<b>DATE:</b>	6 April 2022
<b>FROM:</b>	Miguel de la Mata Acoustics Consultants Australia – Director
<b>TO:</b>	Steven Russell Blasta Brewing Company
<b>SUBJECT:</b>	<b>Lots 1-5 Goodwood Pde, Burswood – Noise Impact Assessment Addendum</b>
<b>REFERENCE:</b>	10.00388R-02

Table 1 Acoustic Review Register

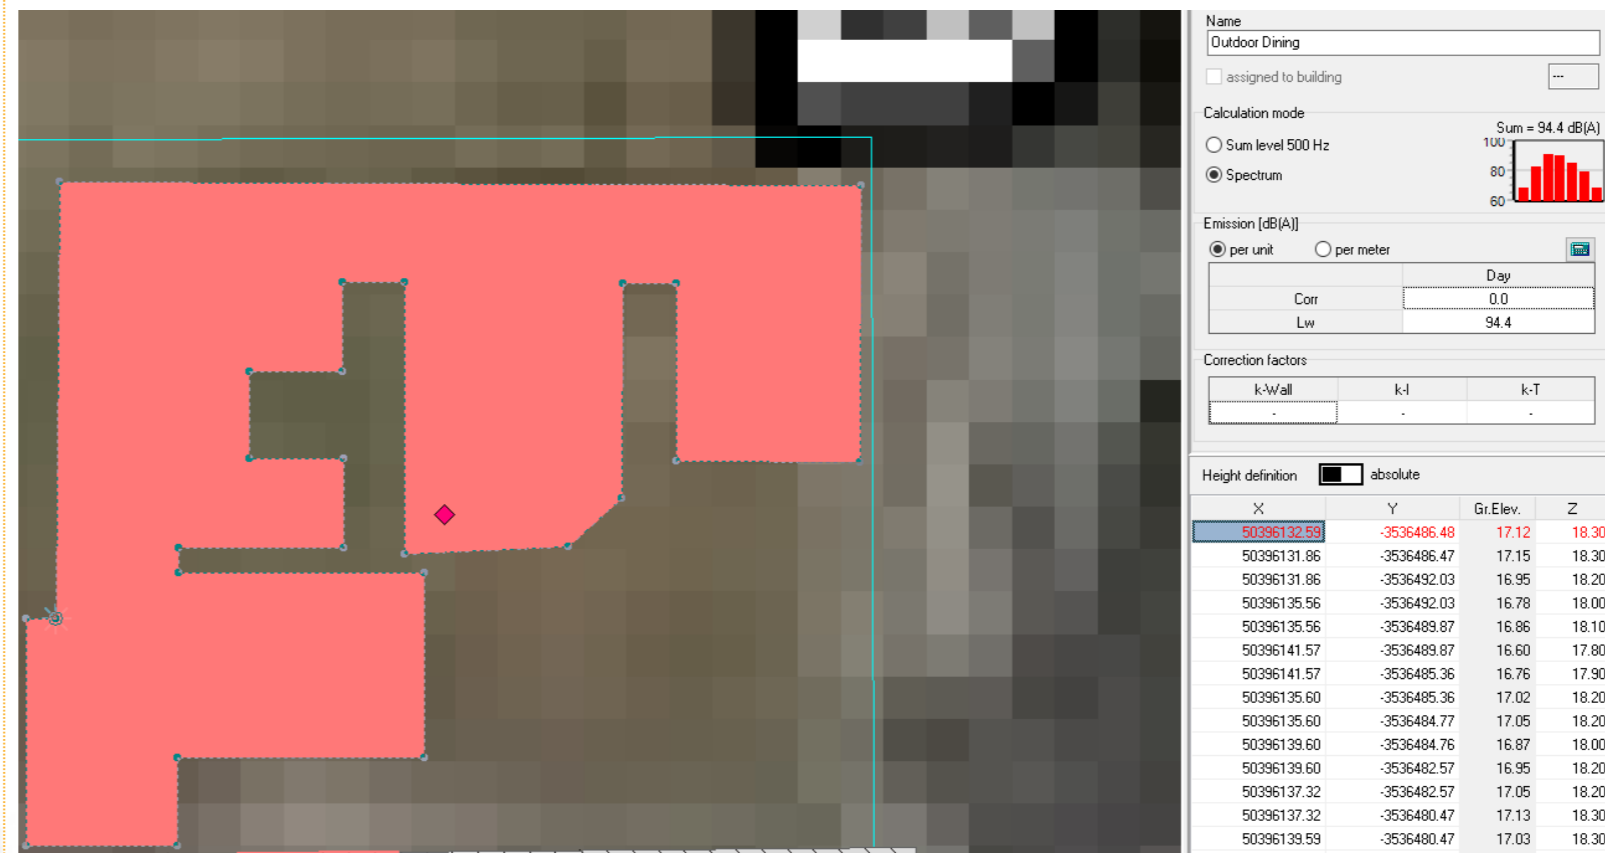
Item	Reviewer Comment	ACA Report Section Reference	ACA Response
	<p>We have referenced Hayne et al (2011) to establish the noise generated by outside crowds and find that the ACA LA10 crowd noise is between 7 – 8 dB too low in outdoor areas. This translates to increased noise reaching neighbouring areas, by between 3 and 8 dB.'</p>		<ul style="list-style-type: none"> <li>- Reverberation Time assumed for assessment (1.5 s), conservative as we recommend 1 s. Thus, calculated absorption A = 280 Sabines.</li> <li>- Reverberant Sound Pressure Level calculated using the formula: <math>L_{A10} = 93 - 20 \text{ Log}[A/(\text{crowd}/G)] + 3</math> - This results in a reverberant sound pressure (<math>L_{A10}</math>) of 87 dBA. While these are overall levels, ACA used 1/1 octave band noise levels throughout all calculations.</li> <li>- Breakout noise calculations were undertaken using a composite transmission loss of the roof as Rw 21 dB. Inclusive of:                         <ul style="list-style-type: none"> <li>o Steel roof sheeting (770 sqm) – Rw 21 dB</li> <li>o Glass inserts (8.5 Vlam Hush recommended) (143 sqm) – Rw 38 dB</li> <li>o Flanking paths through services (0.1 sqm) – Rw 2 dB</li> </ul> </li> <li>- This results in an Area Source of 916 square meters with a total Sound Power Level <math>L_w = 92.4</math> dBA.</li> </ul> <p>This was used directly in the modelling calculation, as shown below:</p>  <p>External Crowds:                      The estimation of external crowd noise was done using the Haynes formulae. In agreement with the reviewer. Shown below is an abstract of our calculation sheets for the conservative maximum crowd numbers of 200 and 50 patrons, where the <math>L_{A10}</math> sound power levels are calculated using</p> $L_{wA10} = 15 \text{ Log} (\text{crowd}/G) + 67$

And the modelling was directly implemented following these sound power levels using an area source 1.2m above the ground level, as shown below:

ACA confirms that the source noise levels used for external and internal crowds are correctly implemented, conservative and suitable for this noise assessment. From measurements conducted by ACA at several entertainment venues, it has been demonstrated that the approach to calculate external crowd (Haynes) would lead to over predictions.

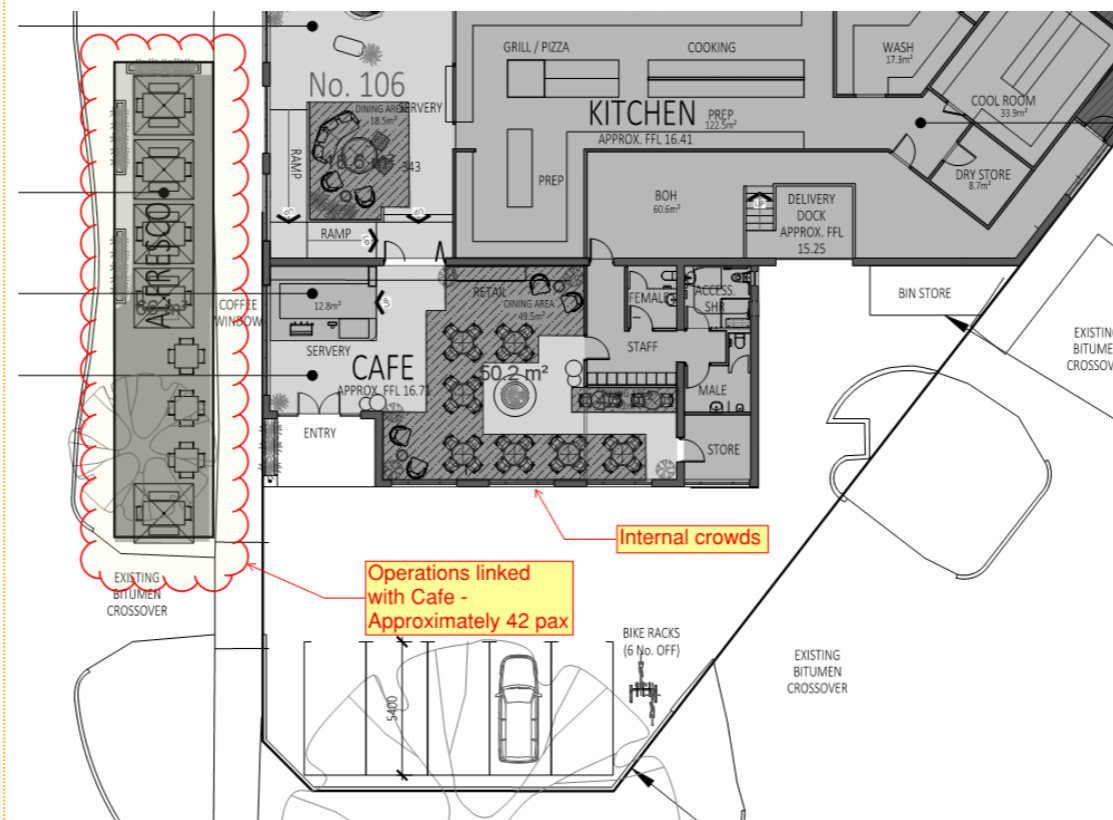
3 *'Sunday operations*  
*The current forecast noise levels do not appear to present Sunday daytime noise emissions involving the Southern Alfresco area and café. These areas are nearest the most-affected residential areas and, as referenced in Sections 2.1 & 2.2 above, it is likely to lead to further noise exceedances.'*

Worst-case Sunday operations have been assessed, again, considering the extreme worst-case scenario, as indicated in Item #1 of this Table.

To consider a Sunday morning scenario, the crowd numbers inside the Bistro, Beer Hall and alfresco areas would have to be realistically assessed (not at full capacity). An assessment of the proposed café and the southern Alfresco is presented below. Based on a worst-case full capacity of the alfresco area, as shown below, the contribution from crowd only at the nearest noise sensitive receiver is **L<sub>A10</sub> 39 dB**. Then, adding up the rest of the possible noise sources during a Sunday morning, noise would go up to **L<sub>A10</sub> 41 dB**. This is compliant with the Sunday assigned noise level of L<sub>A10</sub> 49 dB.
